Service Bulletin

B 0.2 Engine, Installation, **Attachments**

Installation of exhaust gas turbochargers with improved corrosion behaviour.

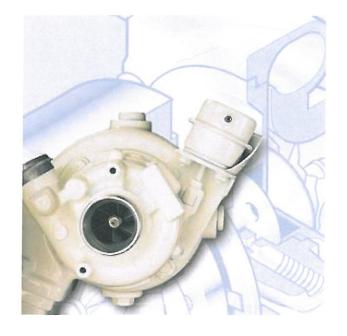
The turbochargers are well protected against corrosion by use of a stainless steel insert. They have been mounted in TDI engines with the following engine numbers and commissioning dates.

Previously used turbochargers were labeled with part number 065 145 701. Turbochargers with improved corrosion behaviour are labeled with part number 065 145 701 A. You will find the type plate on the housing of the exhaust gas turbine.

In case of service please be sure to use only the following spare parts:

Part number	Amount
Turbocharger	065 145 701 A	1
Oil seal	N 138 063	2
Gasket	028 145 757	1
Gasket	065 145 039	1
